Addendum No. 1
May 3, 2022

Project: Webster Area School – 2022 CTE Addition & Remodeling
Webster, South Dakota
Architecture Incorporated Project #2936

Scope of this Addendum:

8.50-C1

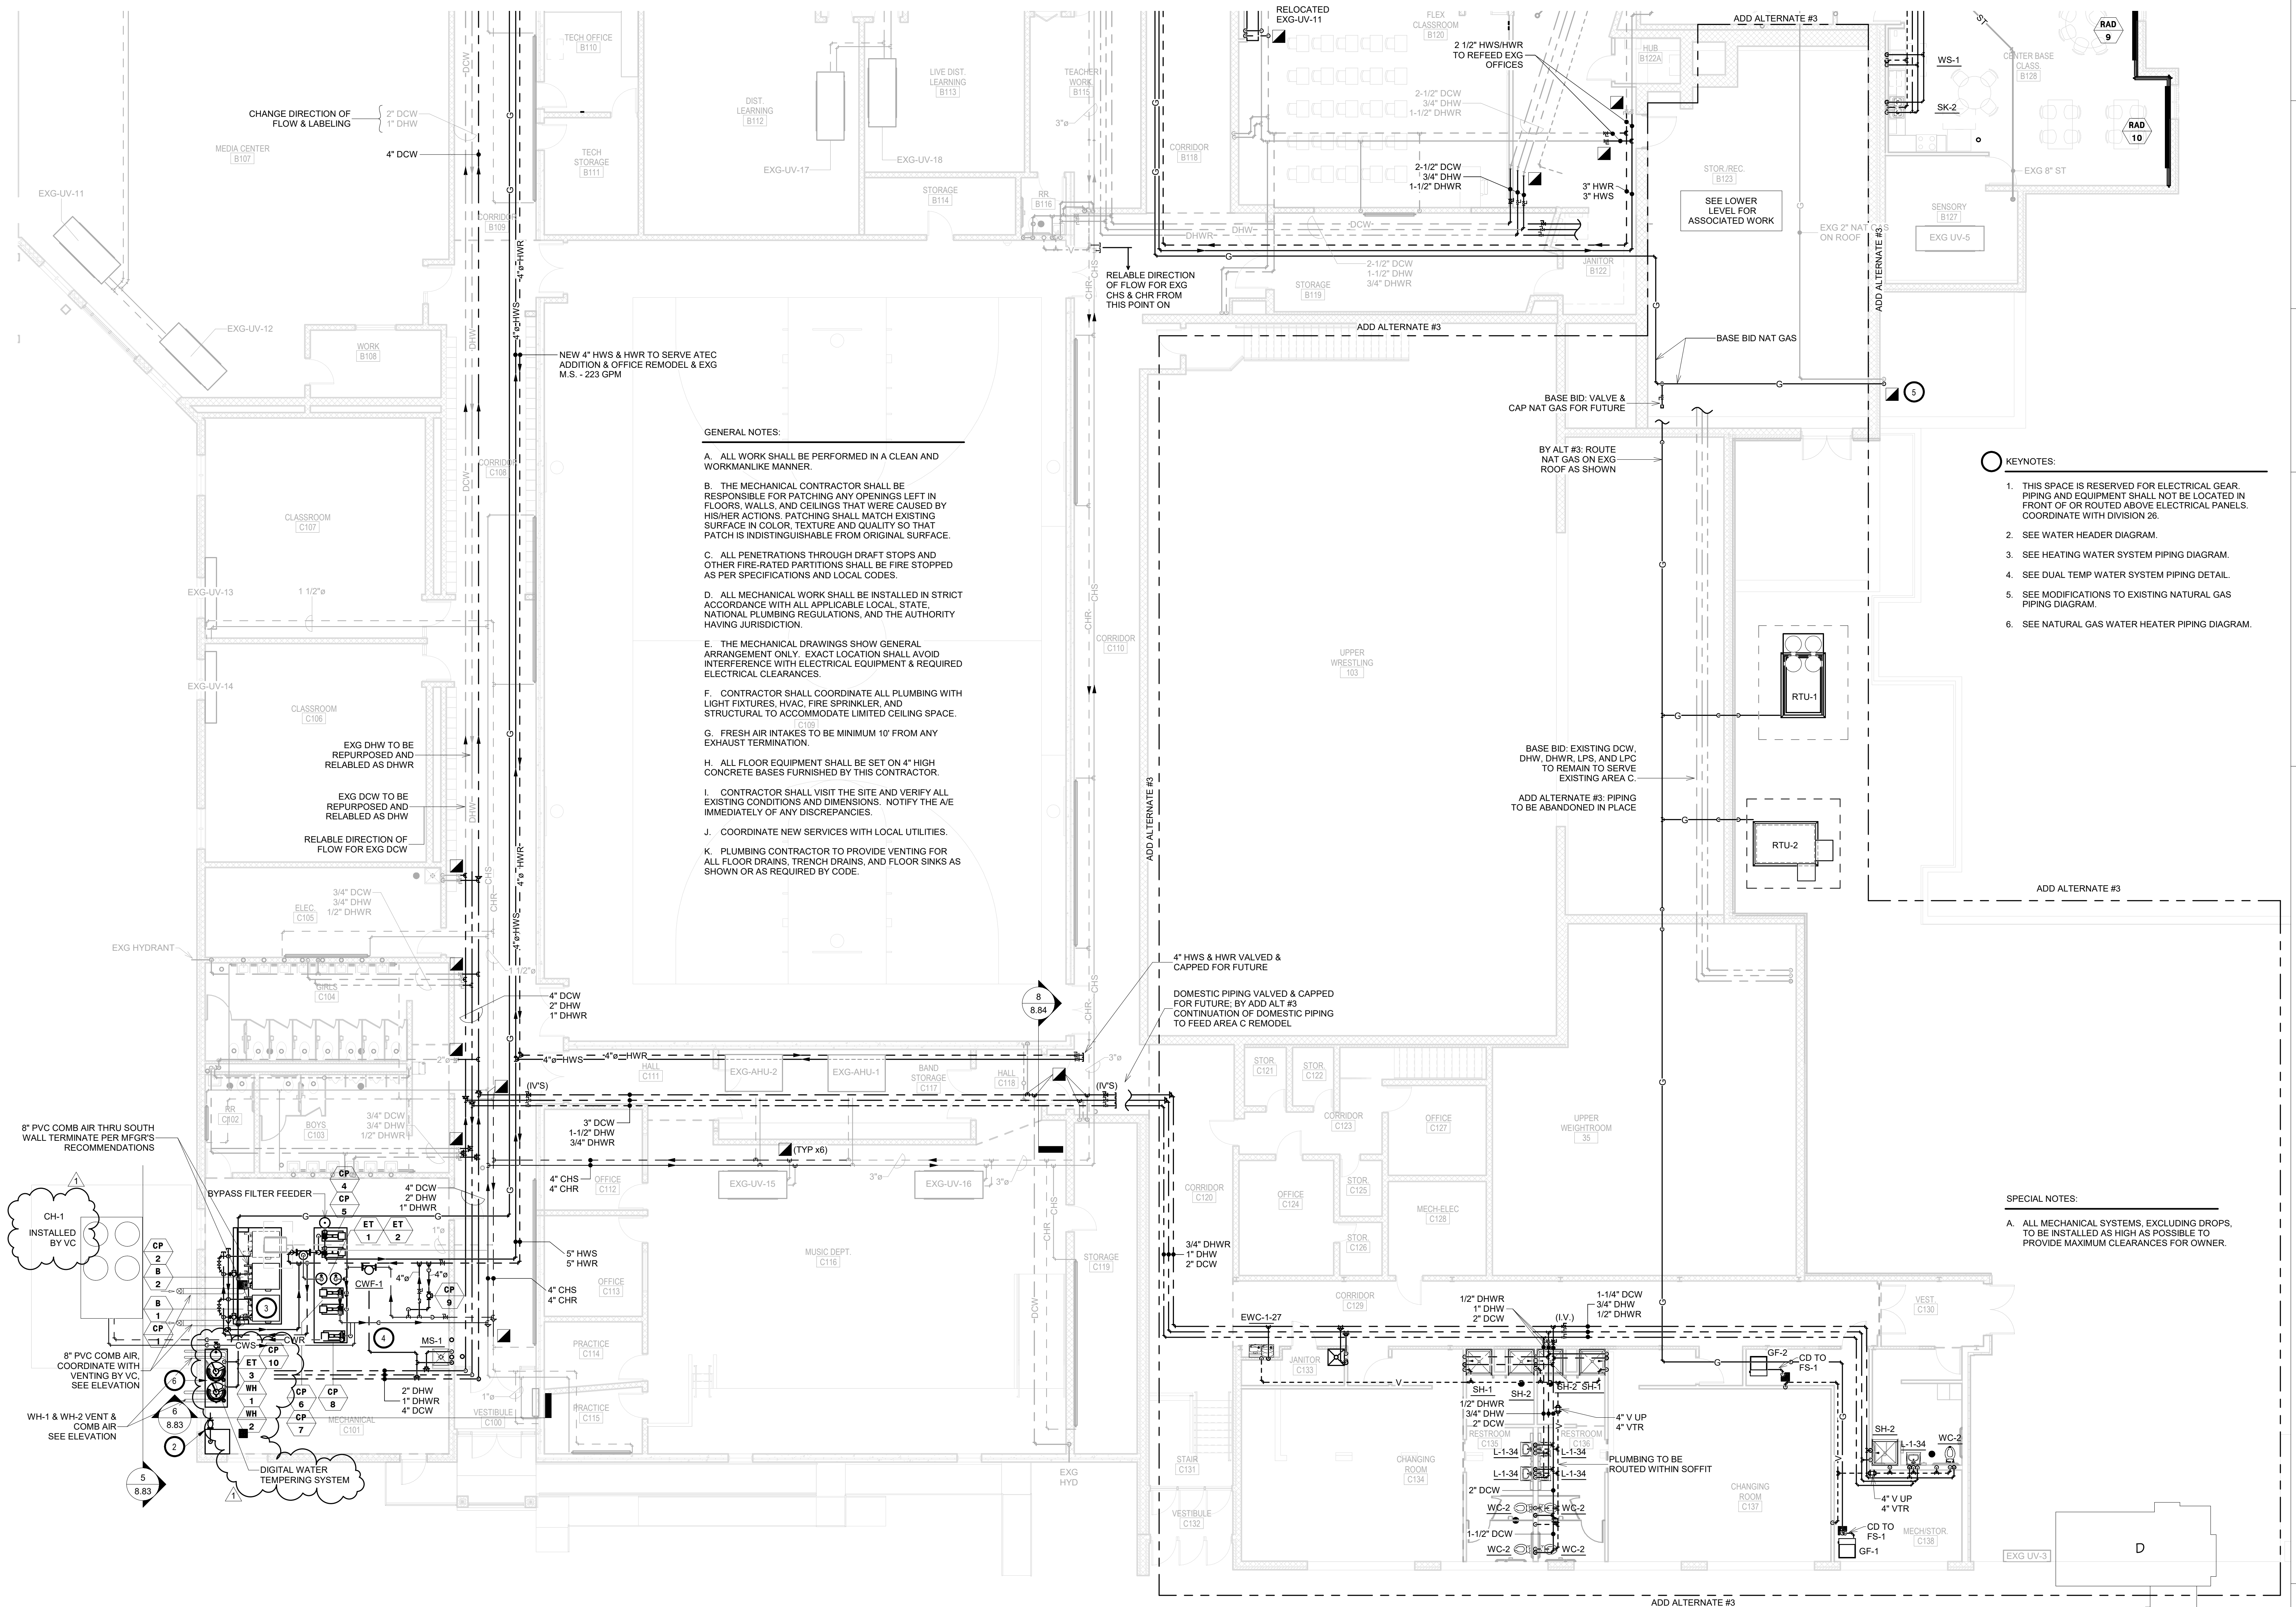
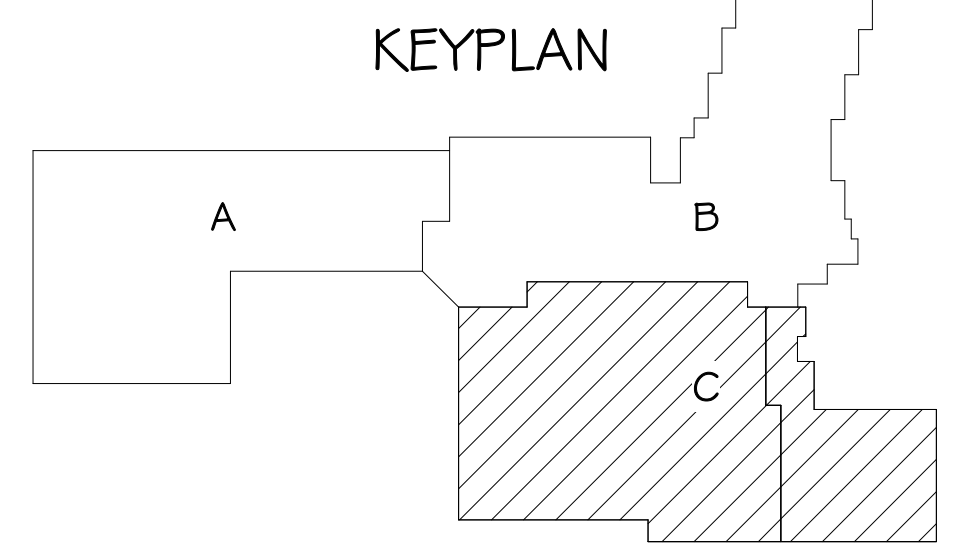
10. SHEET 8.50-C1 – PLUMBING & HYDRONICS – AREA C
 - a. Modify as shown on attached revised drawing.

8.82

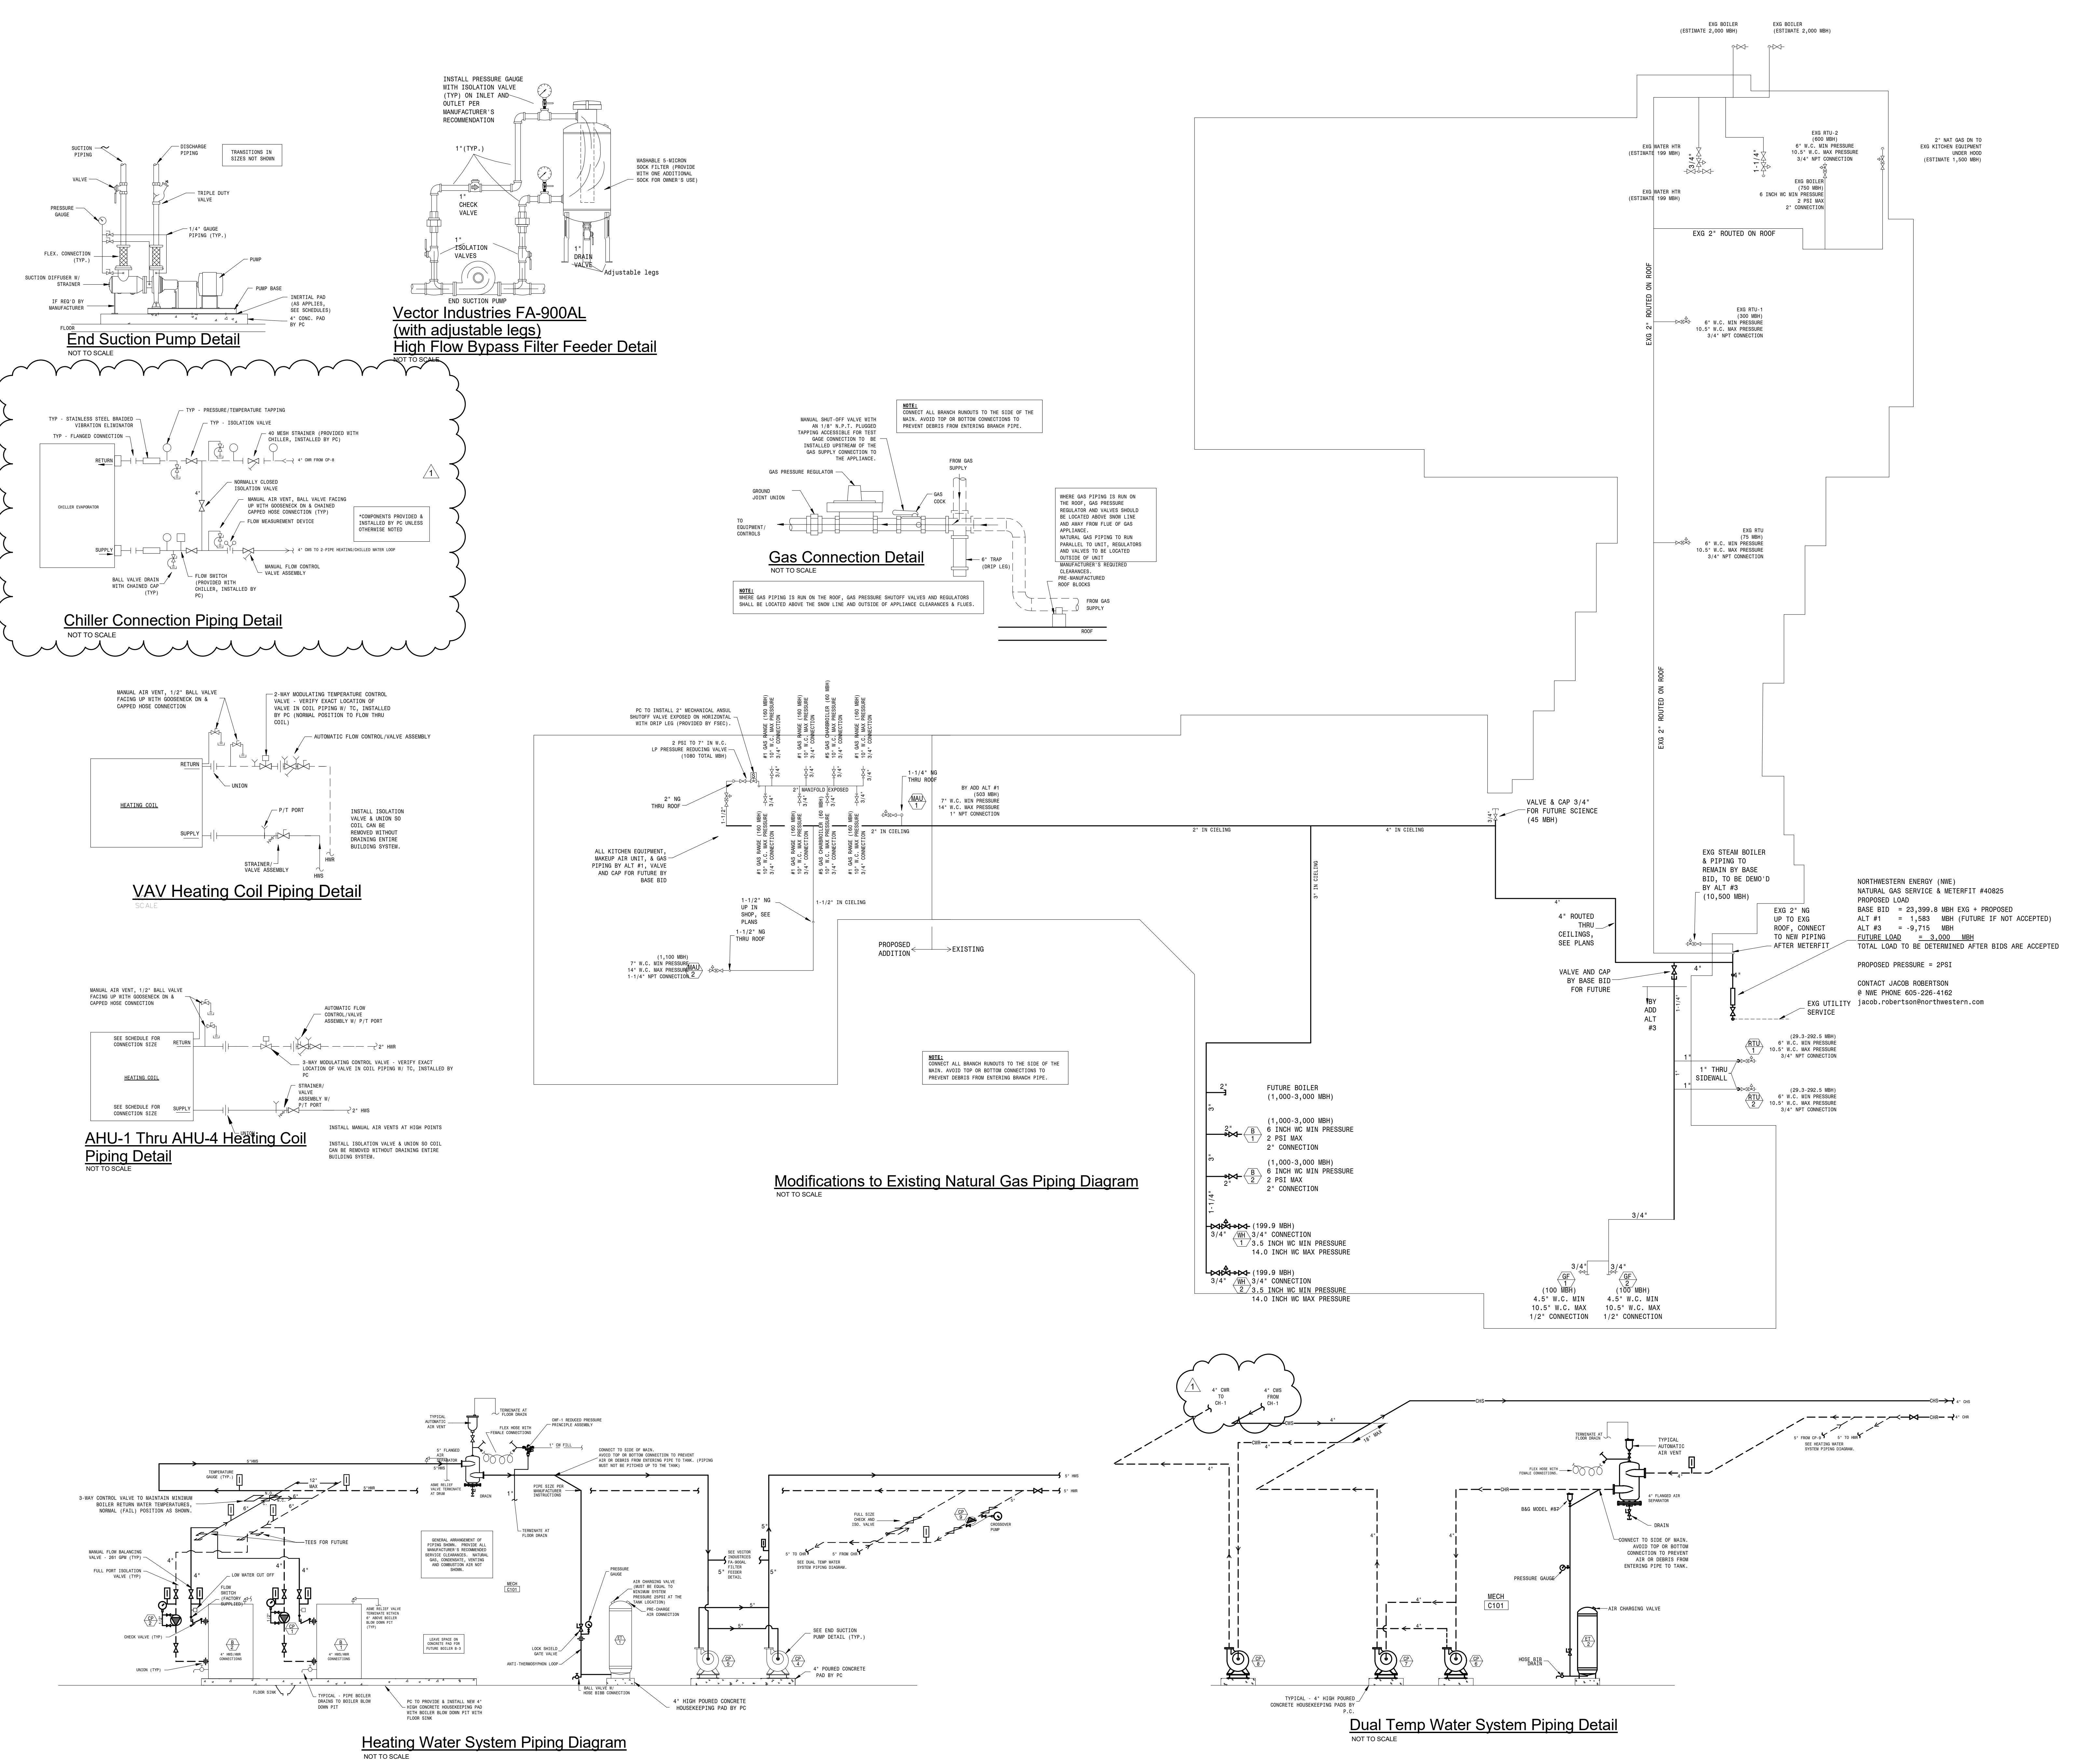
14. SHEET 8.82 – MECHANICAL DETAILS CONTINUED
 - a. Revise details as indicated on attached revised drawing.

DEMOLITION FLOOR PLAN - AREA B - ELECTRICAL
SCALE 0 4 8 12 16

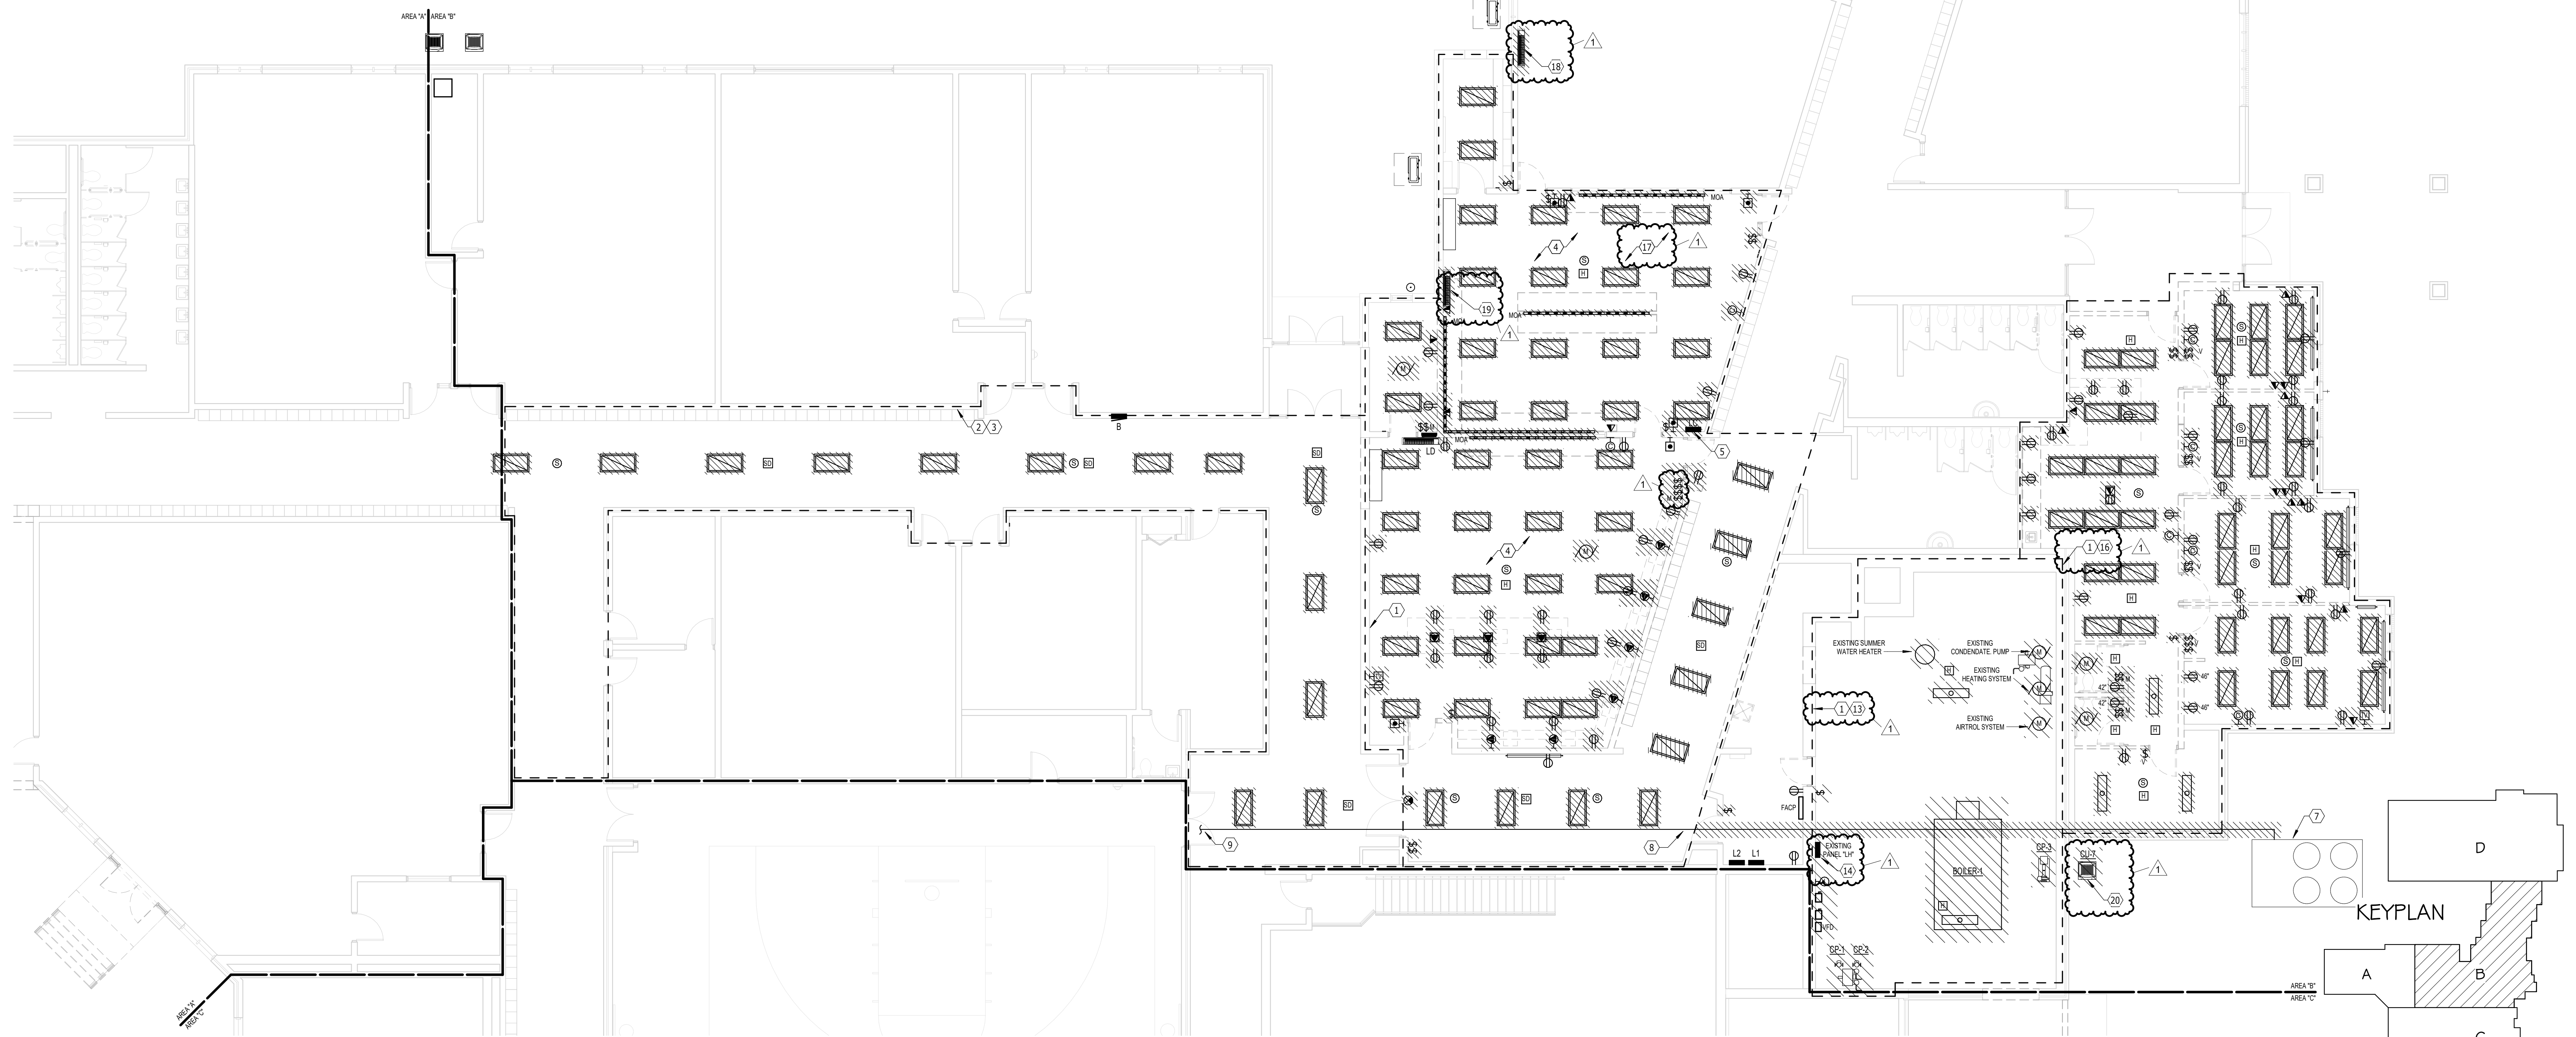
1) DRAWING SHEET 9.22-B – DEMOLITION PLAN – AREA B – ELECTRICAL

- a) See the attached revision drawing.
